Amendment C88 of the Hobsons Bay Planning Scheme

Altona North Precinct 15

Traffic Engineering Peer Review

**STATEMENT TO THE PLANNING PANEL APPOINTED BY THE MINISTER FOR PLANNING FOR
AMENDMENT C88 TO THE HOBSONS BAY PLANNING SCHEME BY ROSS THOMSON, TRAFFIC
ENGINEER**

Figure 6: CIA Model Traffic Count Locations for Calibration

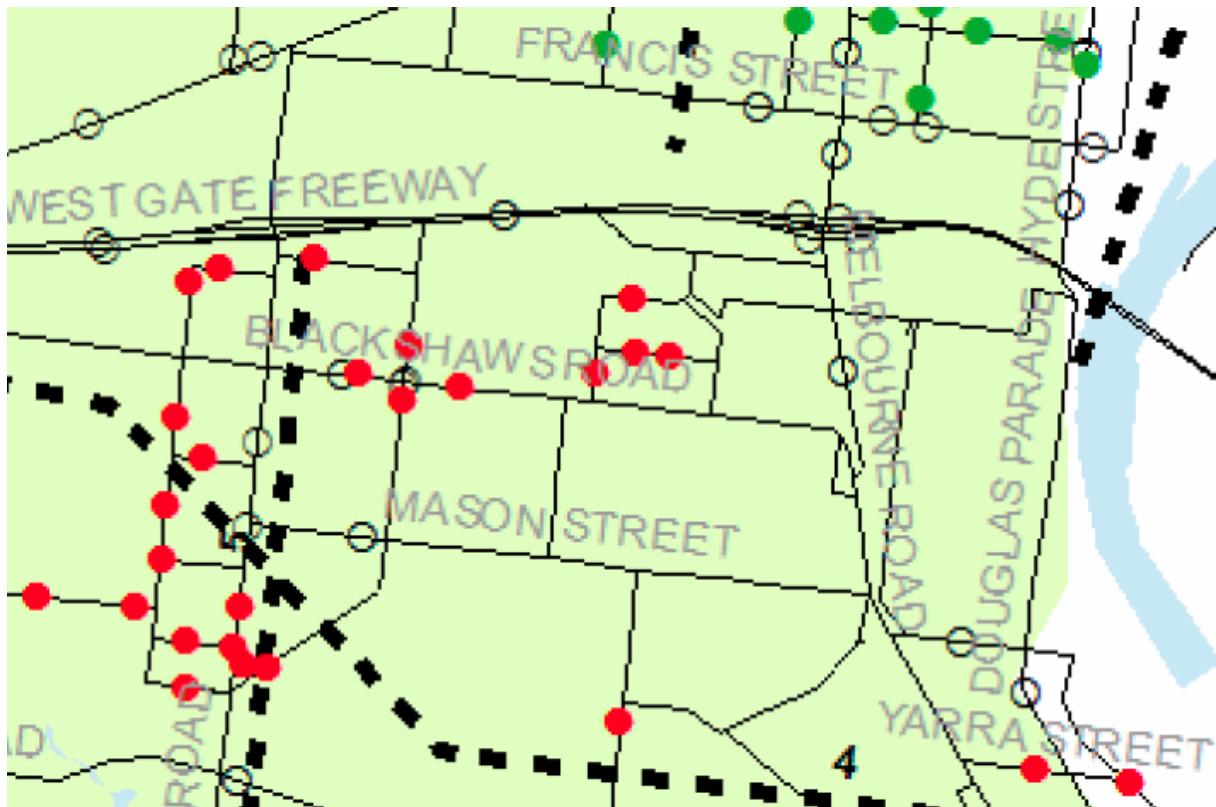
Another limitation of strategic transport models more generally is that their accuracy is limited to the level of detail that it included in the base model. Whereas strategic models are regularly calibrated to a suitable level of accuracy for the arterial road network, they are often less accurate for local roads as the more finely grained nature of the local road network is not included in the model.

An extract from the Calibration and Validation report for the CIA model showing the locations where counts were undertaken to calibrate the model is presented in Figure 6. In this figure count locations are represented by red spots or black circles.

Figure 9: AM Peak Travel Time to West Gate Bridge via Blackshaws Road/Millers Road

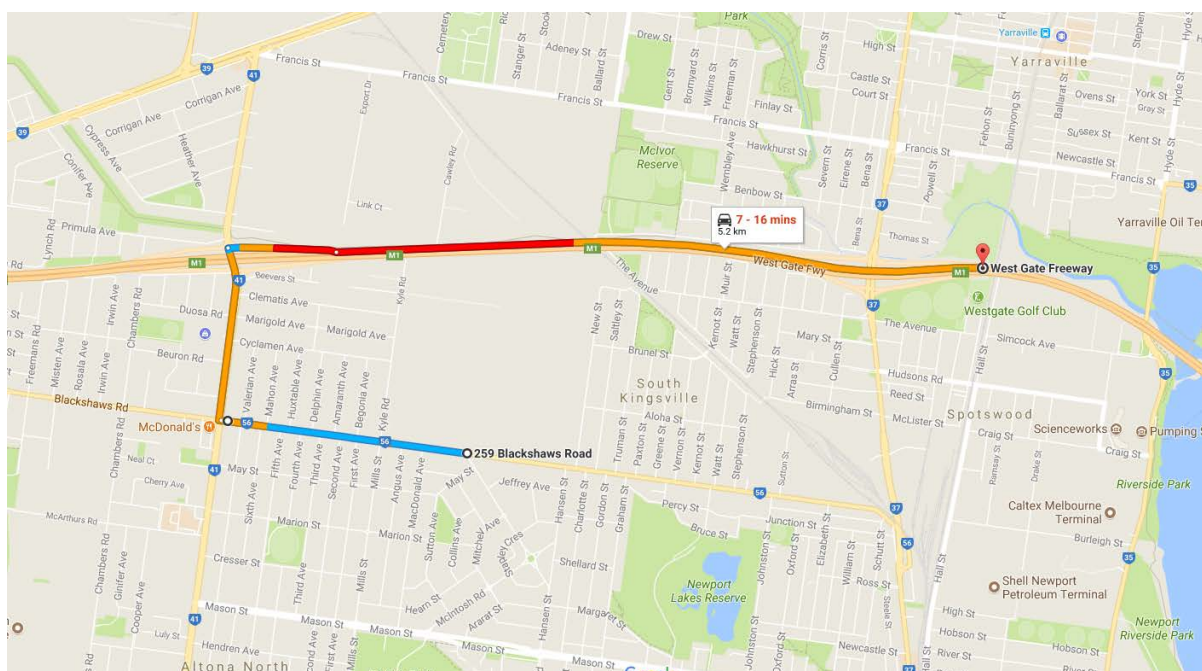
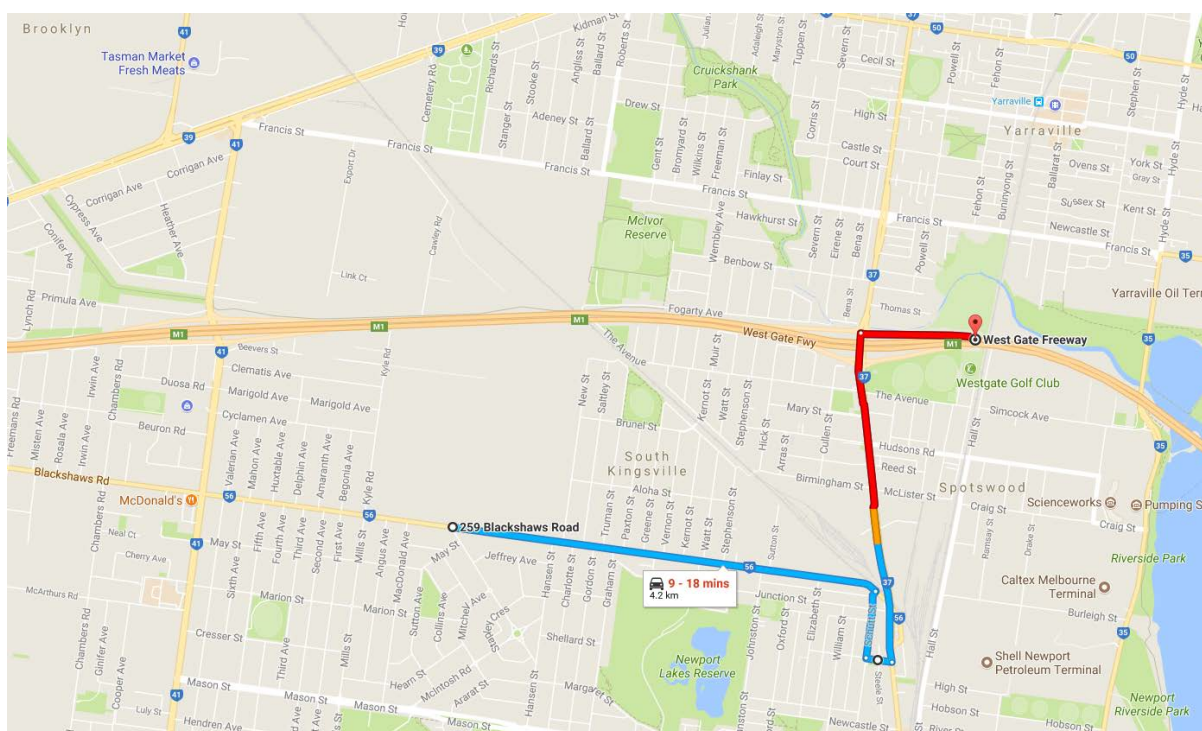
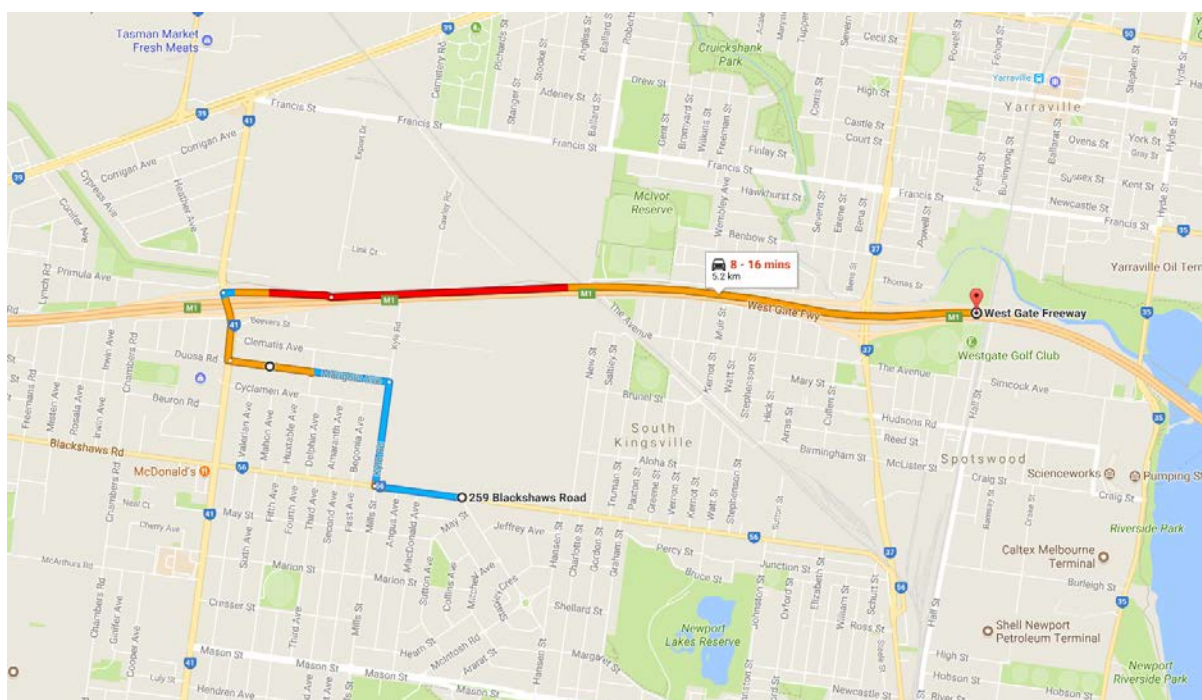
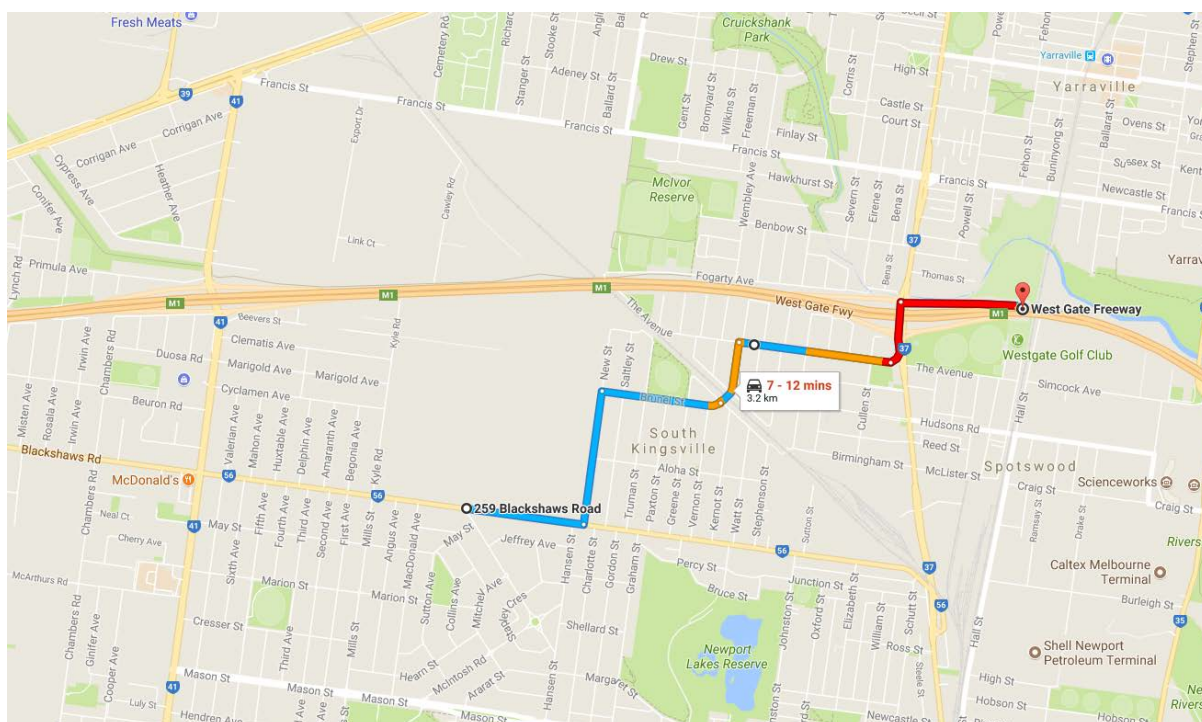
To further highlight the irregularities with the CIA modelling, I have obtained screenshots from the Google Maps application to represent travel times from the Precinct 15 site to the West Gate Freeway to the east of the Melbourne Road interchange during the AM peak period between 8am and 9am via the 4 alternative routes discussed in Section 4.1. These results are presented in Figure 9 through to Figure 12.

Figure 13: Blackshaws Road/Millers Road Intersection Works Recommended by Council/VicRoads

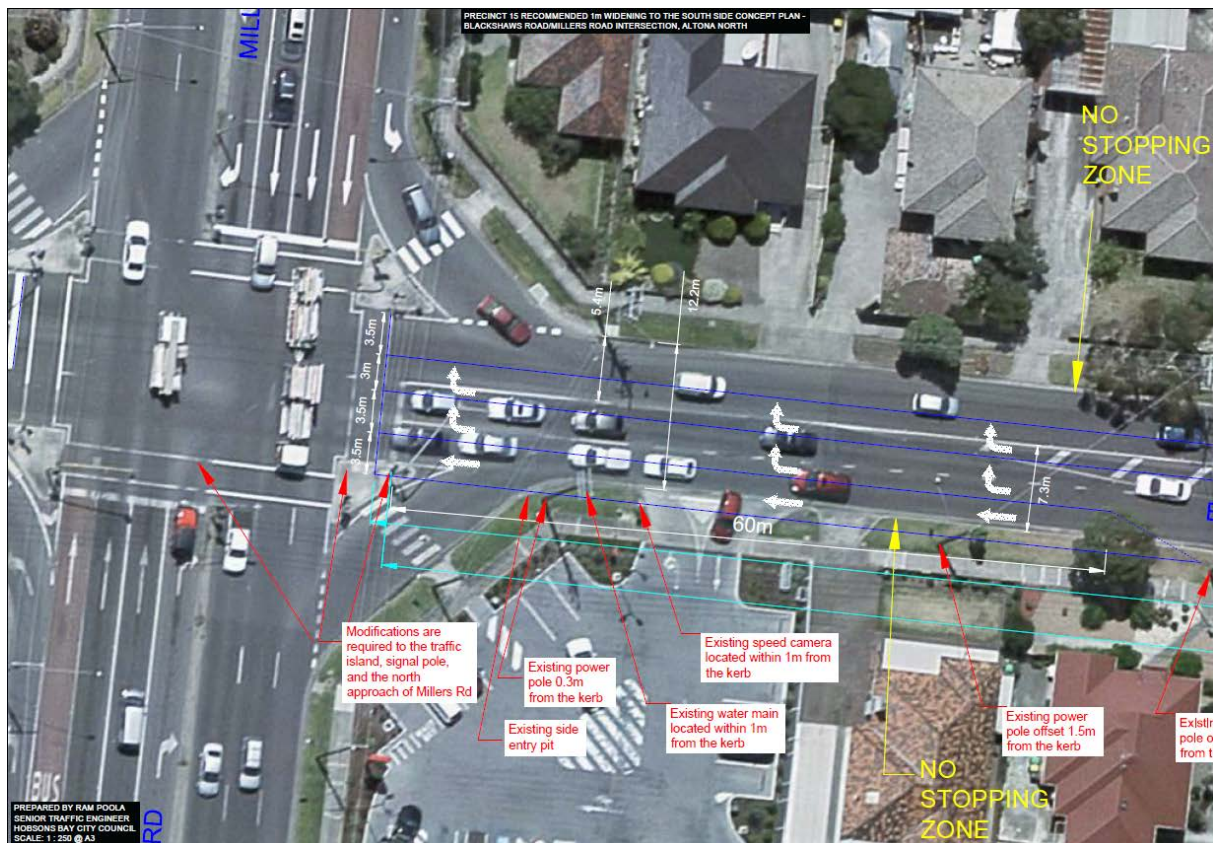
Council and VicRoads have explored further alternatives to improve performance at this intersection which include minor widening of the Blackshaws Road east approach to include three stand-up lanes including a through traffic lane in addition to the two right turn lanes.

A series of concept plans have been prepared by Council to show the amended arrangement, with one such plan presented below at Figure 13.

- f) The DCP item at Millers Road/Blackshaws Road should be modified to incorporate the scope of works proposed by VicRoads and Council subject to meeting swept path requirements,

Figure 14: Proposed Blackshaws Road Cross-Section

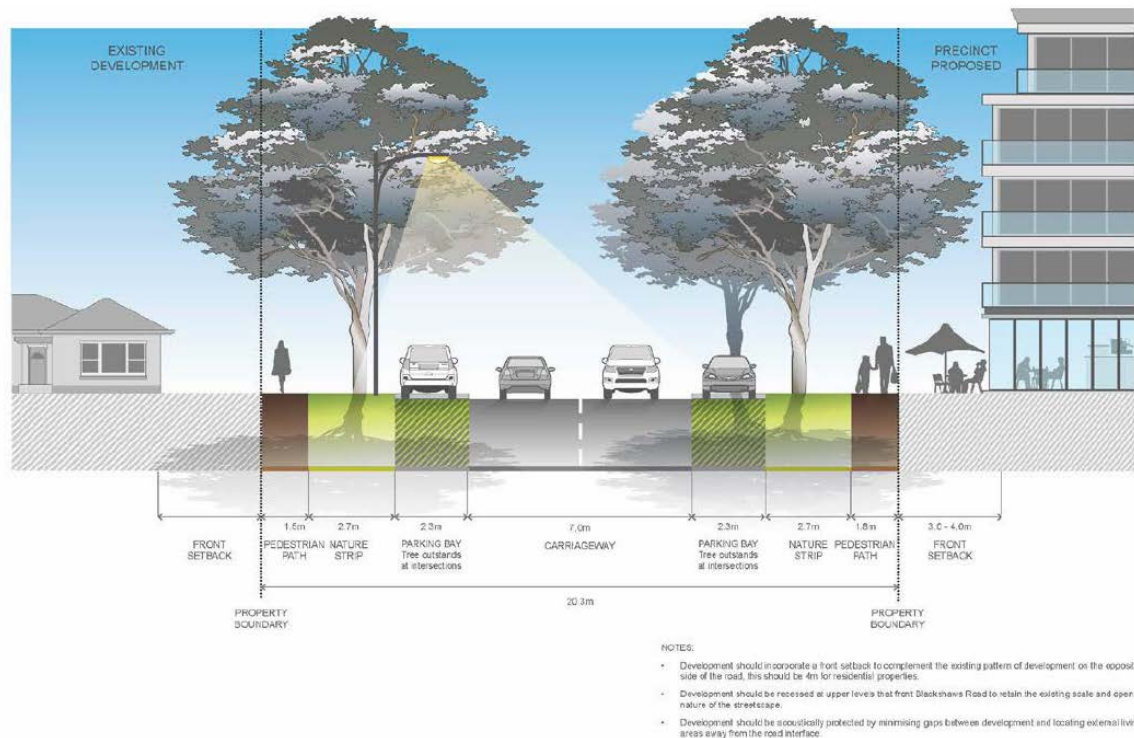
There is some conflict within the CDP relating to the proposed cross-section for Blackshaws Road. Figure 1 in the CDP suggests that it is to consist of a 7.0m wide carriageway with indented parking bays as shown in Figure 14.

This cross-section is not compatible with the provision of on-road bicycle lanes which are shown in Plan 8 of the CDP as presented in Figure 15, are included as an item in the Precinct Infrastructure Plan, are included in the VicRoads Principle Bicycle Network as presented in Figure 16 and form part of the Hobsons Bay Strategic Bicycle Plan.

The cross-section presented at Figure 1 of the CDP is also inappropriate in my opinion as much of frontage of the site will be taken up with protected right turn lanes into the two signalised access points, Hansen Street and also to Kyle Road as per my recommendation above.

- n) The proposed Blackshaws Road cross-section at Figure 1 of the CDP should be amended to include on-road bicycle lanes in place of indented parking,

Figure 17: Recommended Bus Route Changes

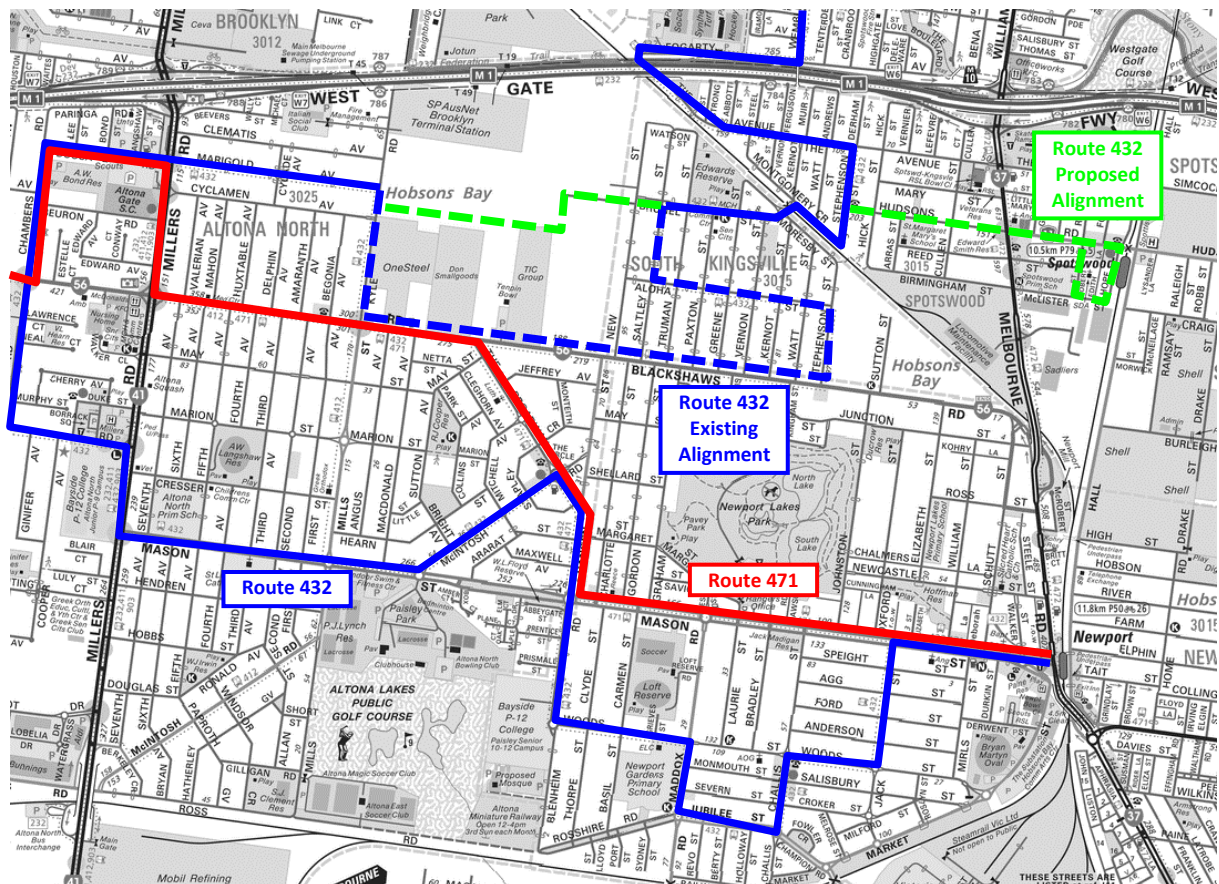
The existing Route 432 service provides access to both Newport and Yarraville Railway Stations but is very circuitous as demonstrated in the diagram at Figure 17.

To alleviate this issue, I support the recommendation to provide a direct service through the site to access the closest railway station at Spotswood utilising the signalised crossing of Melbourne Road at

Hudsons Road. This could be achieved by straightening out the existing Route 432 service to remove the existing sections along Blackshaws Road and Aloha Street. This would save time on the existing service and may allow the connection to Spotswood Railway Station to be included without the need for additional resourcing of buses. I note that the proposed connector streets within the Precinct 15 site have been designed with suitable cross-sections such that they can support a bus service.

As identified in the ITS and the Precinct Infrastructure Plan this change would necessitate the creation of a bus loop and provision of a bus stop in the vicinity of Spotswood Railway Station. Improvements to bus priority through signalling changes at Millers Road/Marigold Avenue as discussed earlier and bus stop improvements along Marigold Avenue and Brunel Street would also support this service.

Figure 18: Bicycle Street Example (VicRoads TEM)

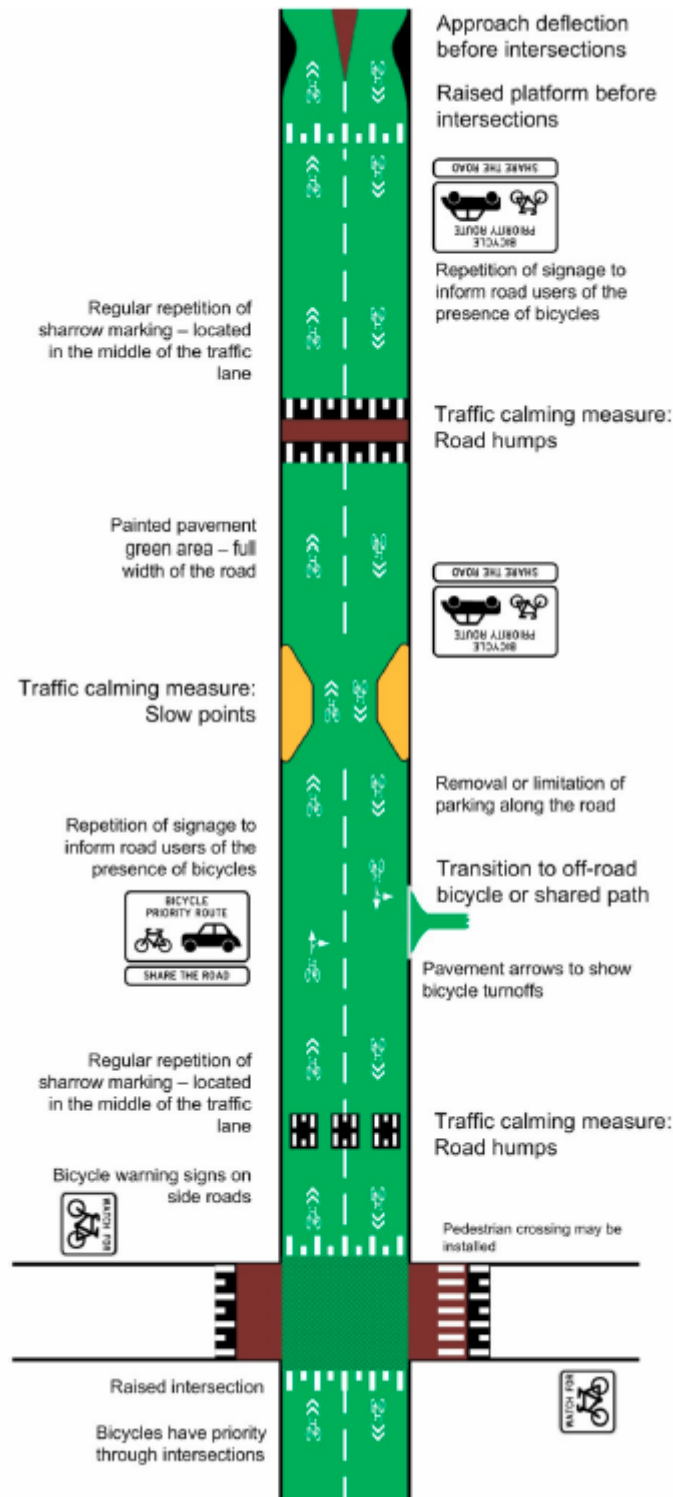
A diagram from the relevant section of the VicRoads Traffic Engineering Manual is presented at Figure 18 illustrates a number of additional features which should be considered for implementation in Cyclamen Avenue and Aloha Street subject to consultation with local residents as part of the LATM study.
